City of Portland, Maine - Building or Use Permit Application

Permit No: 02-0062	Issue Date: FEB 5 2002	CBL: 430 A019001
-----------------------	---------------------------	---------------------

Past Use: Single Family	Proposed Use: Single Family / Amendment to permit # 01-0554. Window changes, gas fire, bath revision and delete bedroom.	Permit Fee: \$30.00	Cost of Work: \$0.00	CEO District: 2
Proposed Project Description: Amendment to Permit # 01-0554. Alterations		FIRE DEPT: <input type="checkbox"/> Approved <input checked="" type="checkbox"/> Denied <i>N/A</i>		INSPECTION: Use Group: <i>R-3</i> Type: <i>SB</i> <i>BOCA 1991</i>
		Signature: <i>[Signature]</i>		Signature: <i>[Signature]</i>

1st Floor
A+B Chapman
20 Berwick St
1/4" = 1'0"
4/6/01
rev. 12/28/01

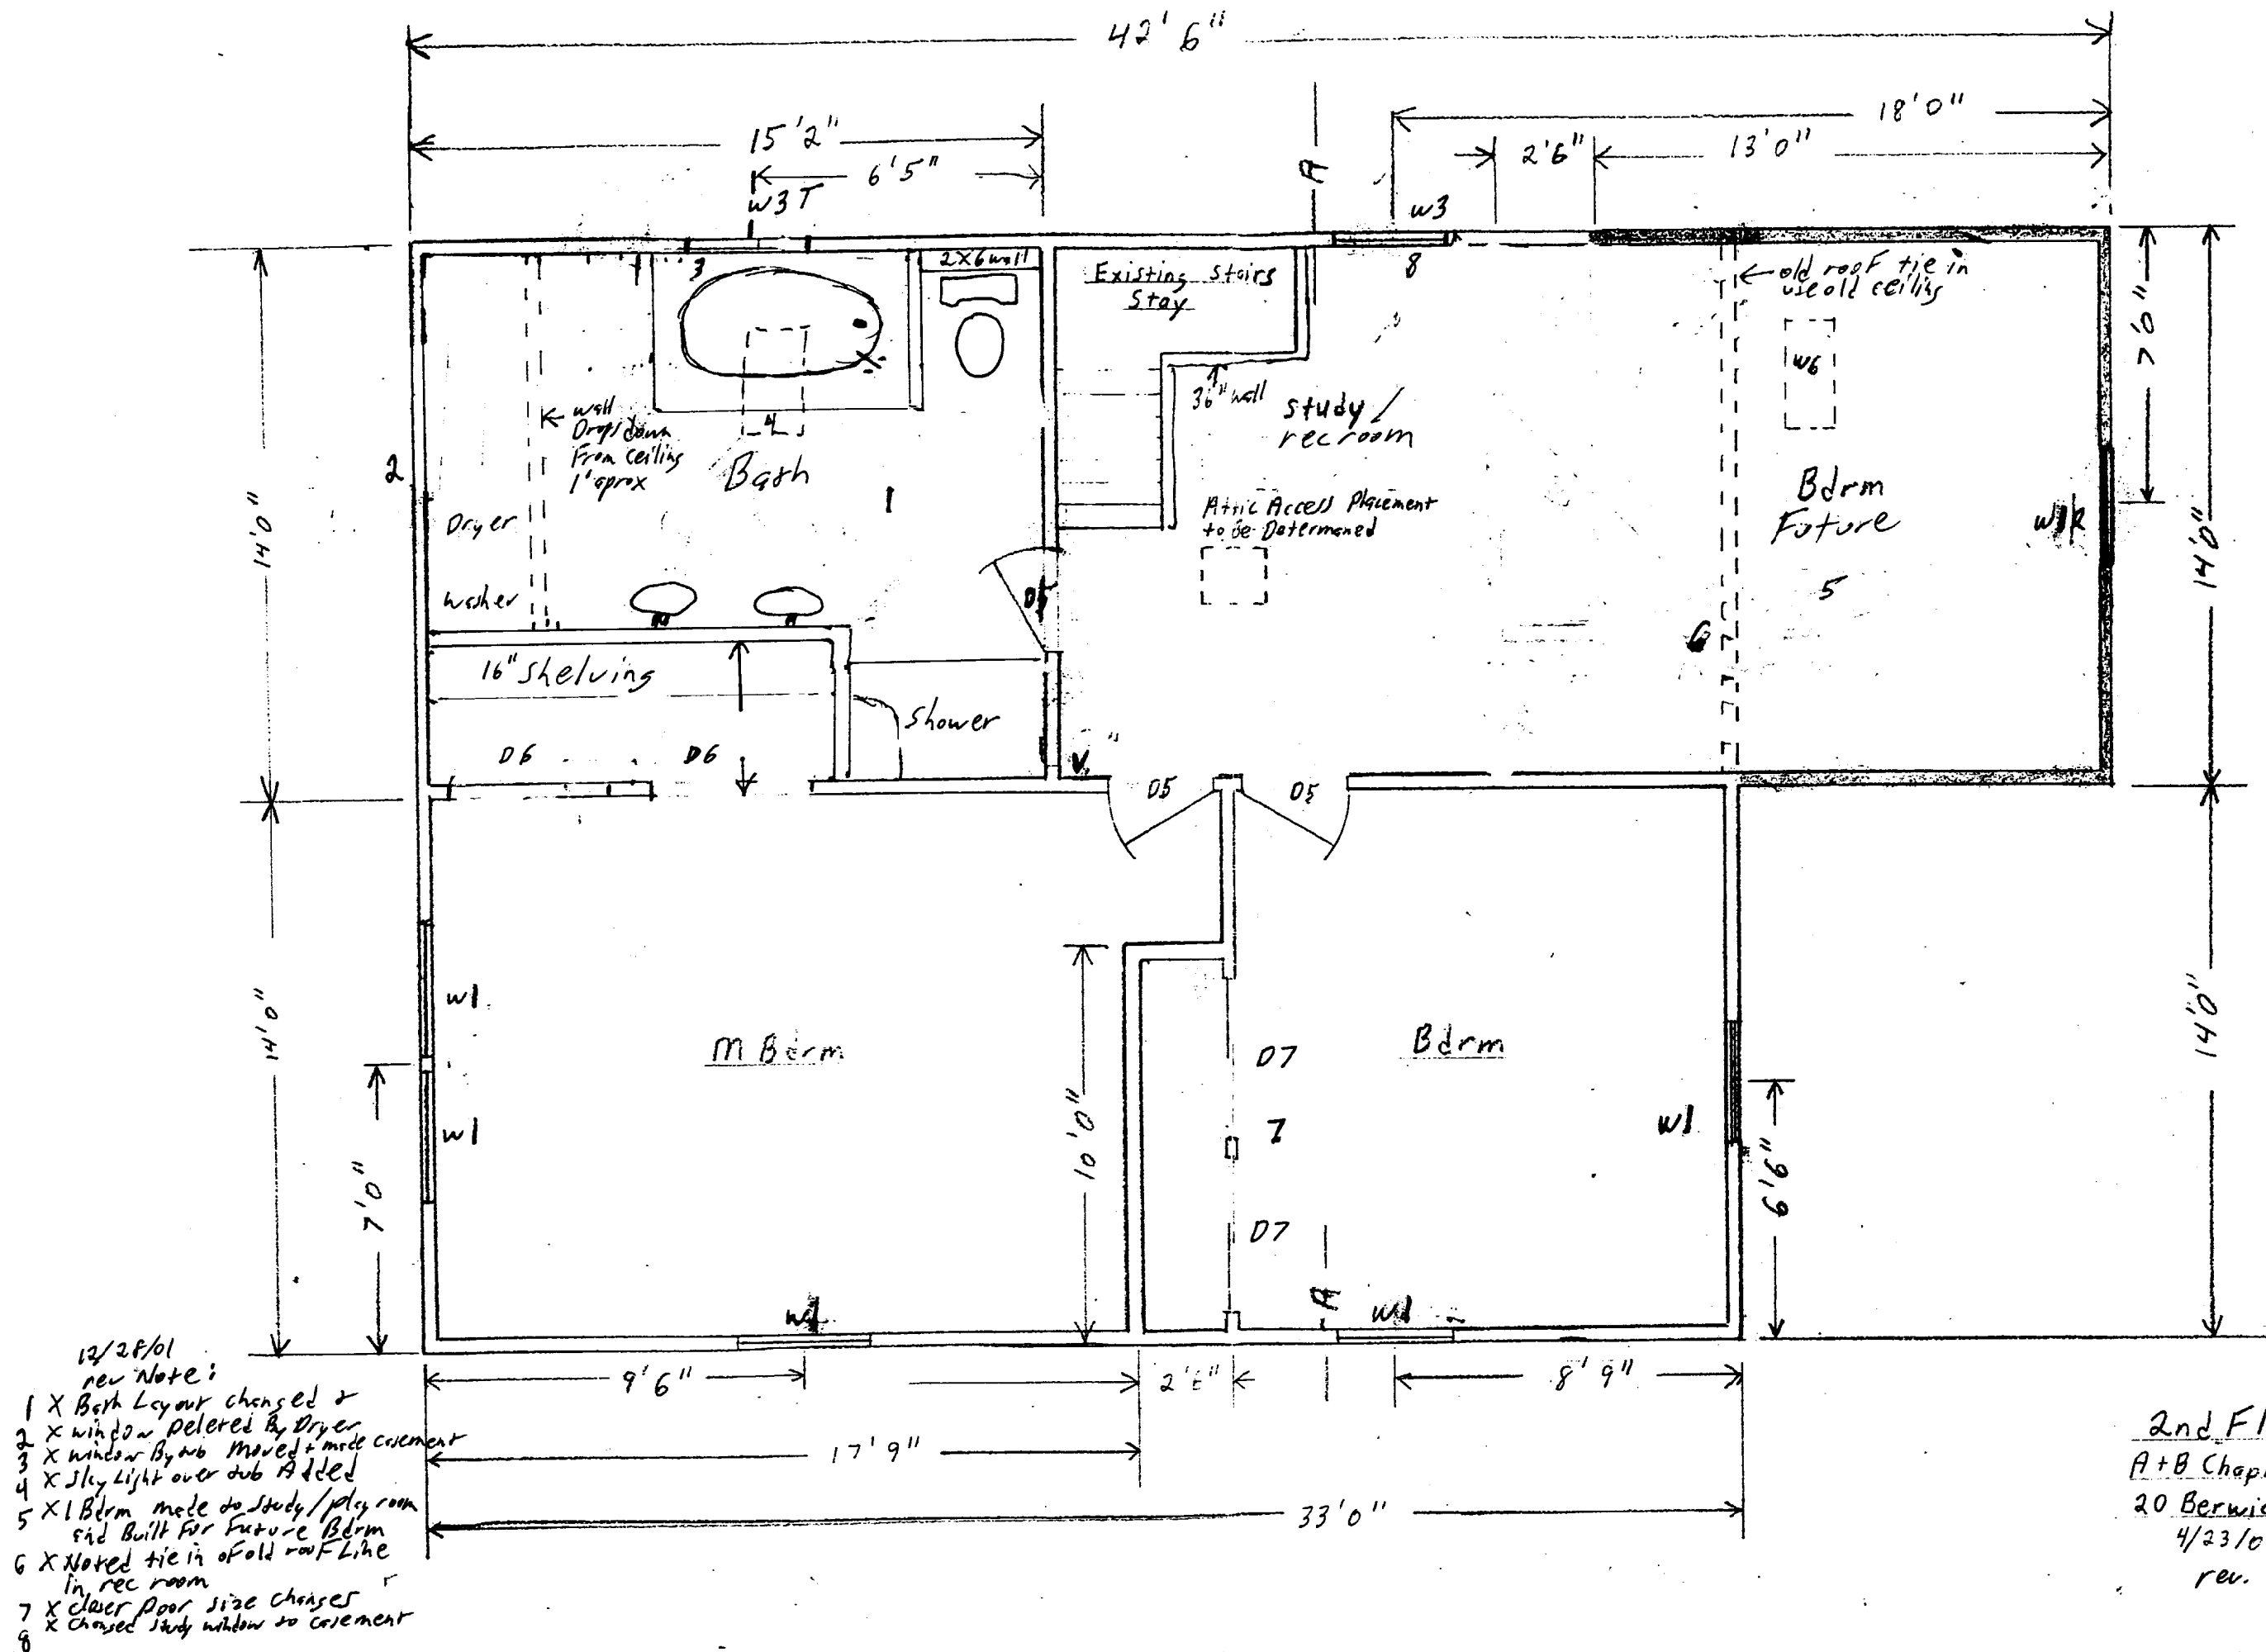
- rev. Notes:
- 1 X Existing porch to stay + Build New rear porch
 - 2 X changed kitchen window to W 7
 - X showed placement of hot stove
 - X changed mud room window to casement
 - X Deleted window in kitchen (cooktop area)
 - X Add 12" Base Cabinet 24" wall move 12" wall

Foundation
A+B Chapman
20 Berwick St.
1/4" = 1'0"

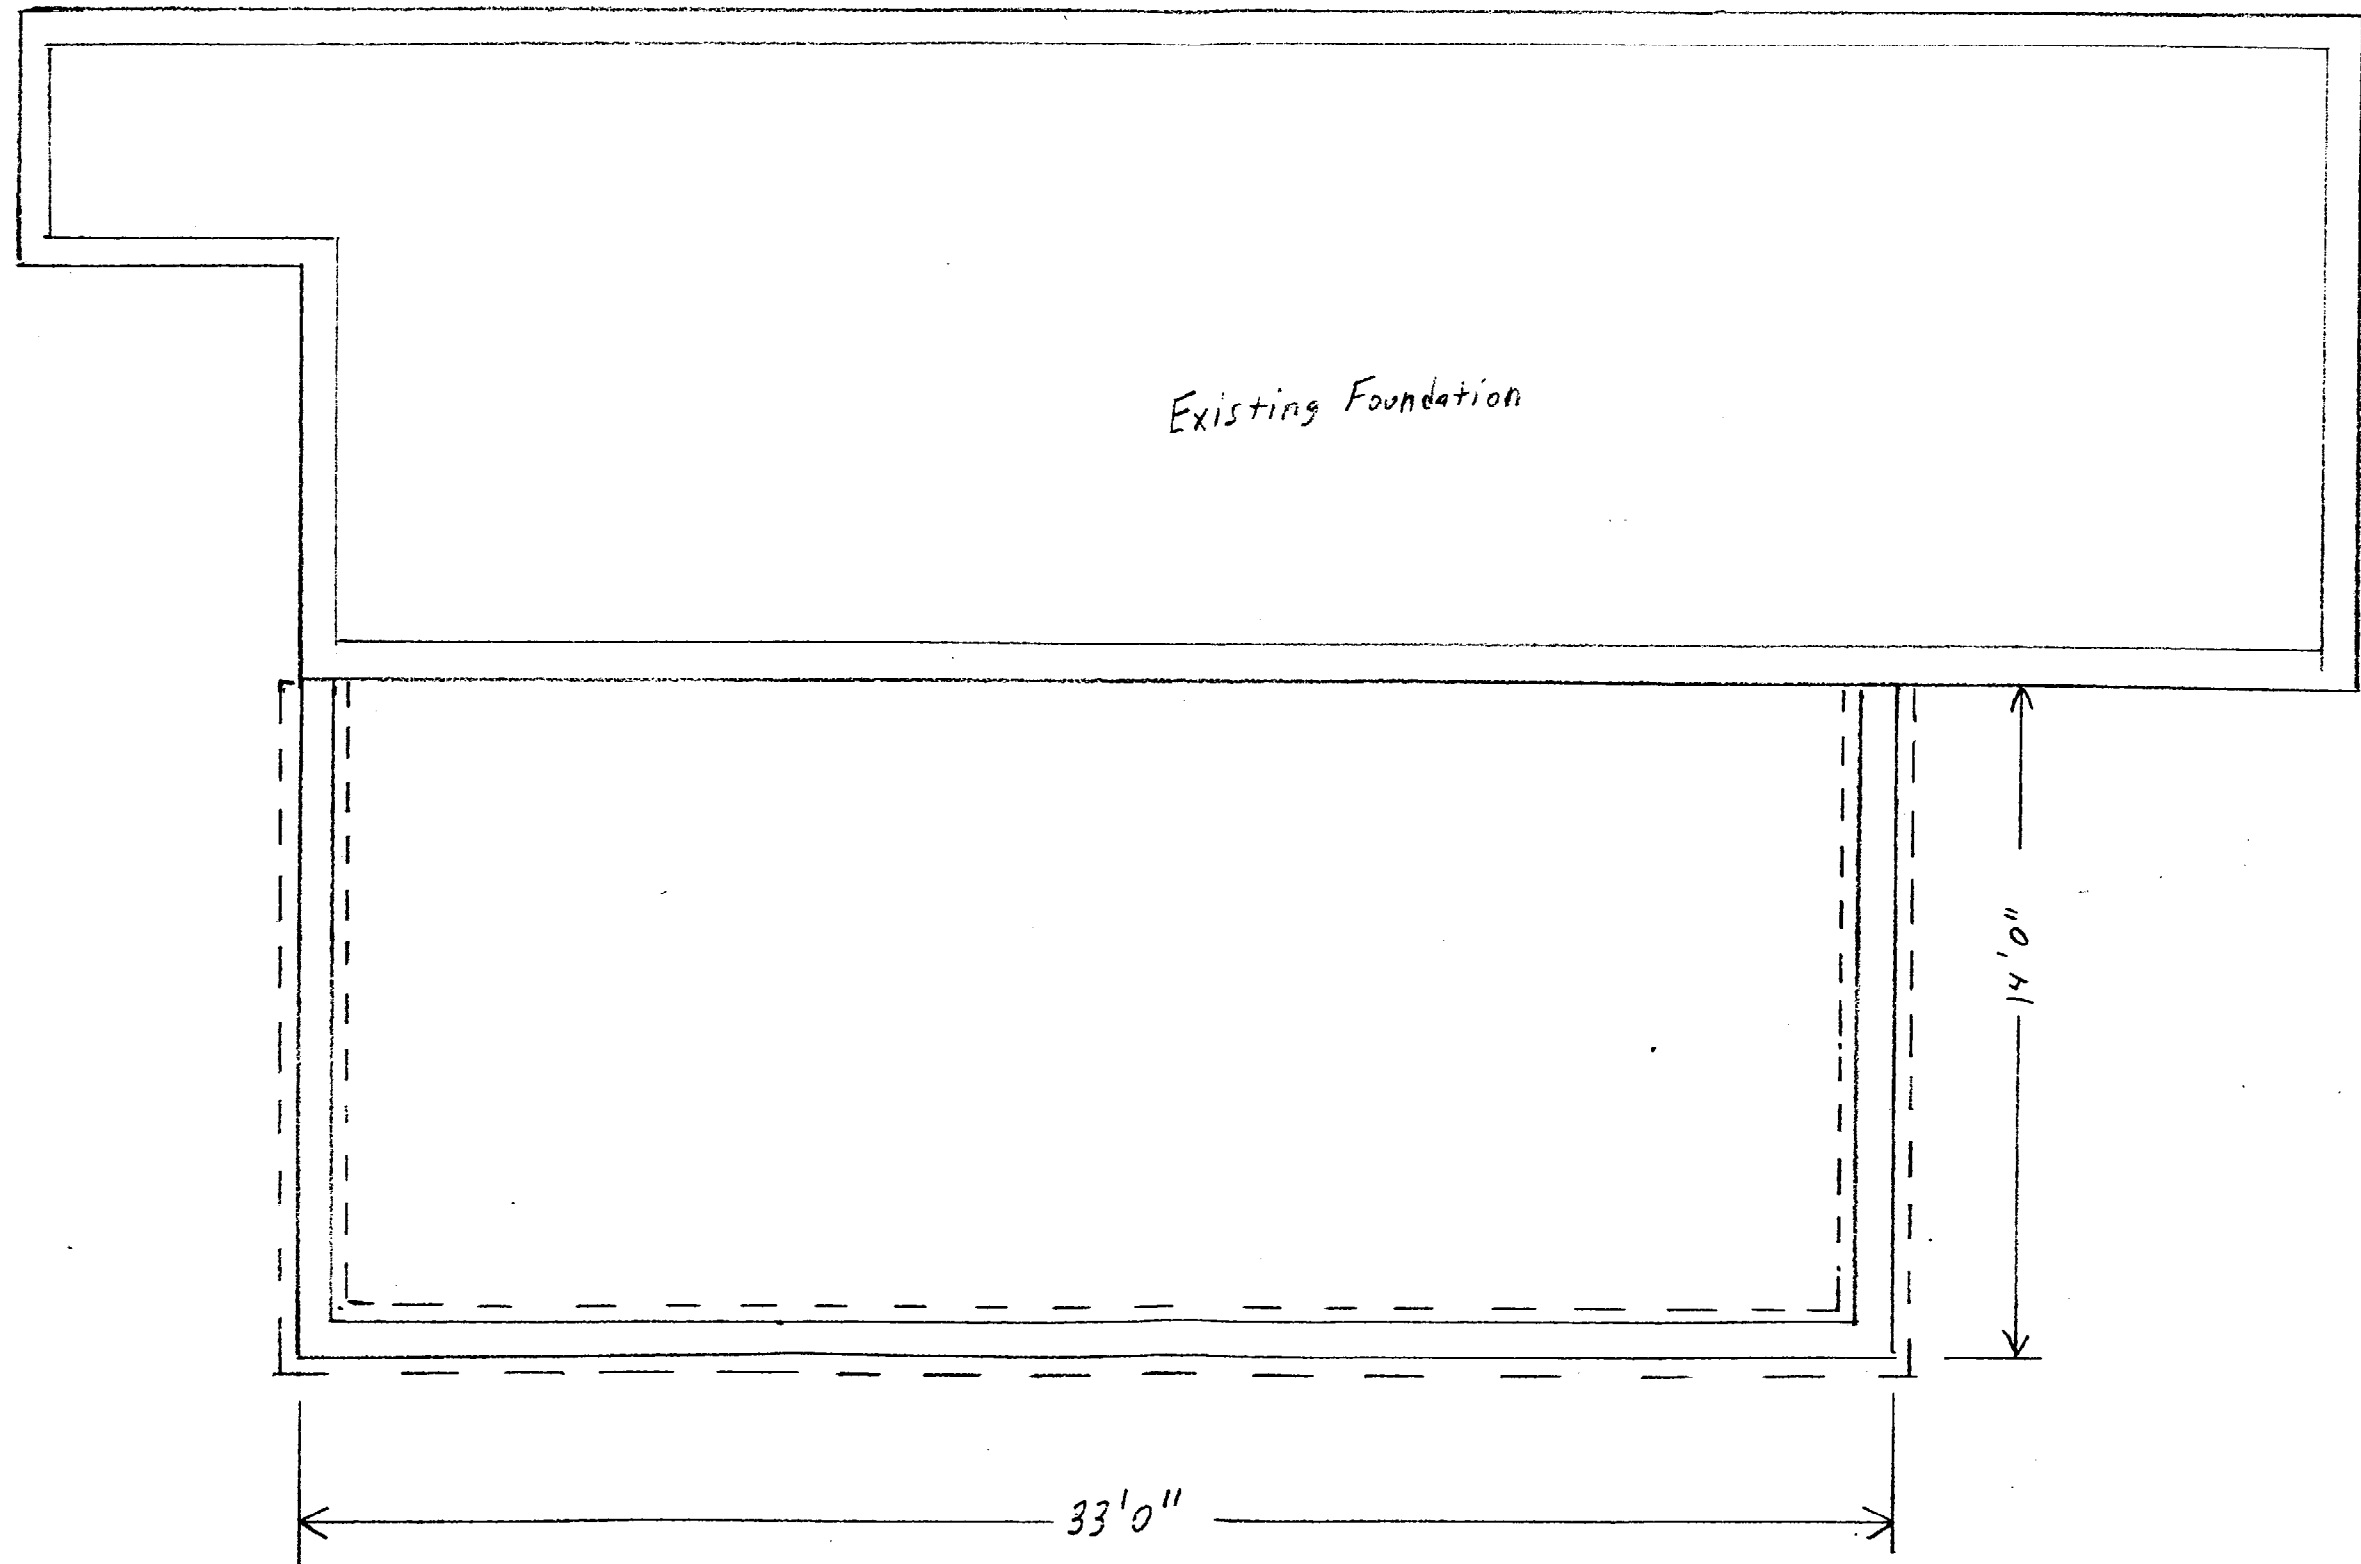
rev. Note
X changed window for kitchen

$\frac{1}{4}" = 1'0"$
A + B Chapman
20 Berwick St
Portland ME
rev. 12/28/01

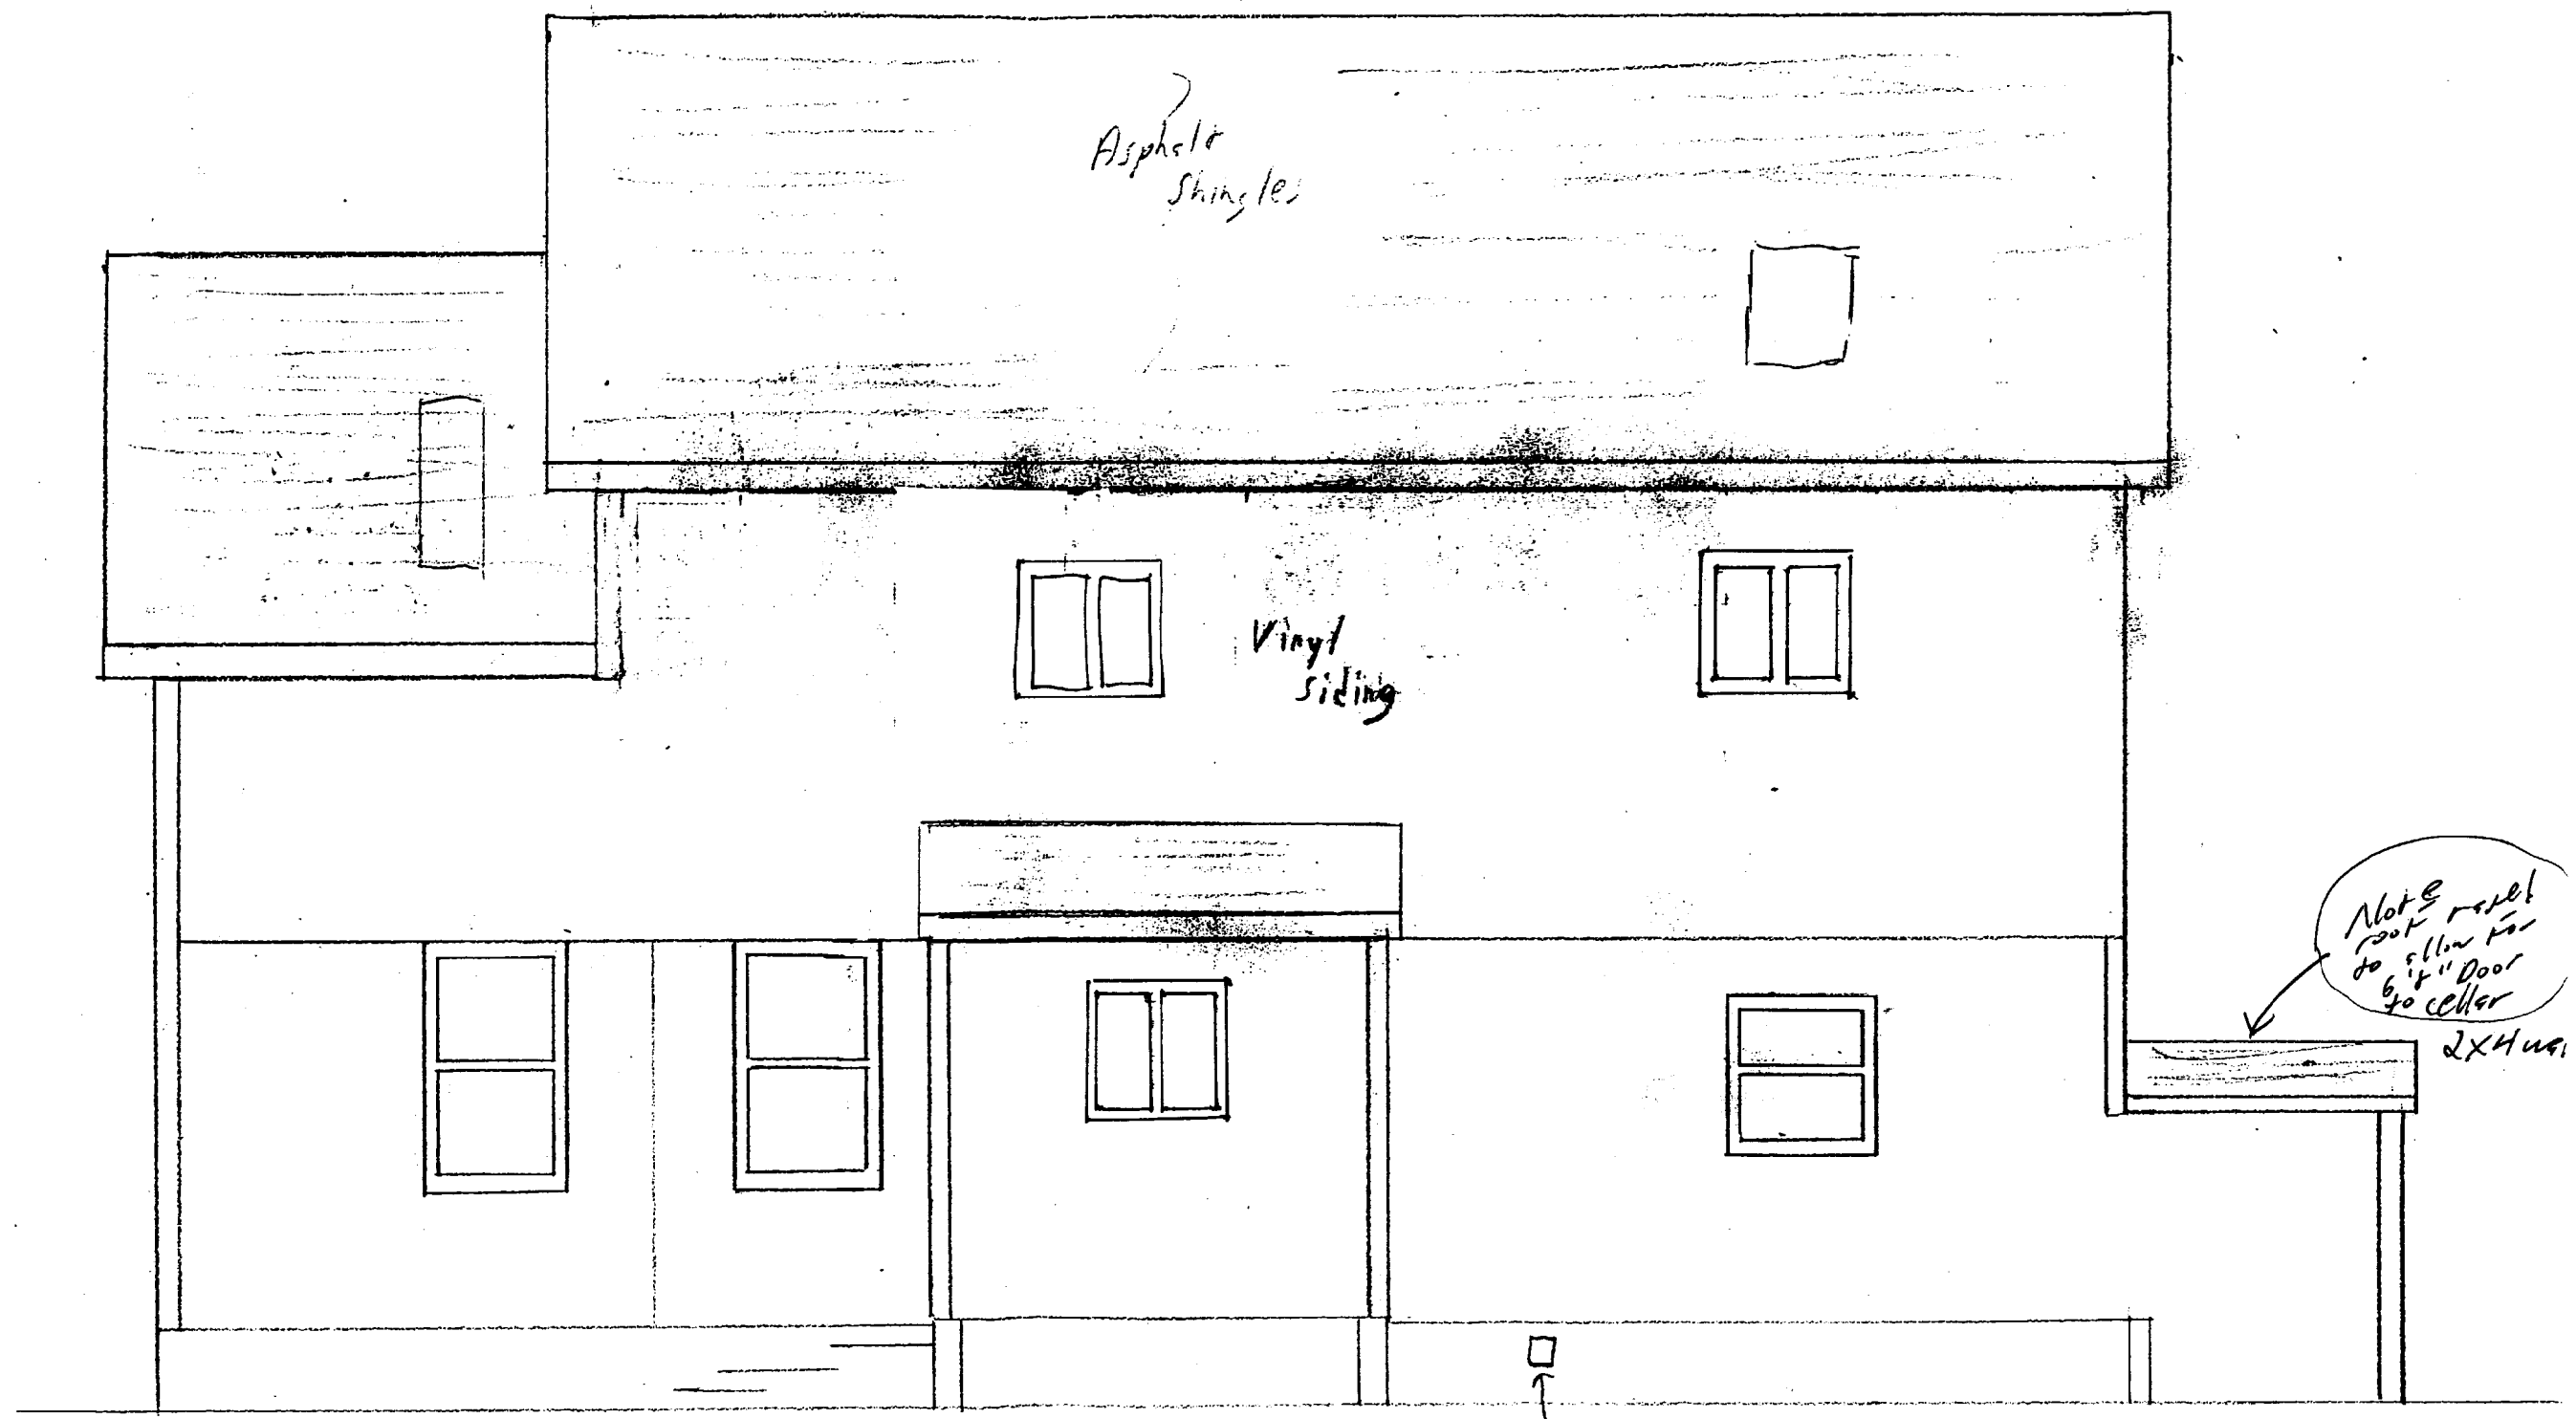
rev. Note
X Added Note on cellar way change
X changed Mudroom window to casement
X changed 2nd Flr windows to casement
X remove sky light note
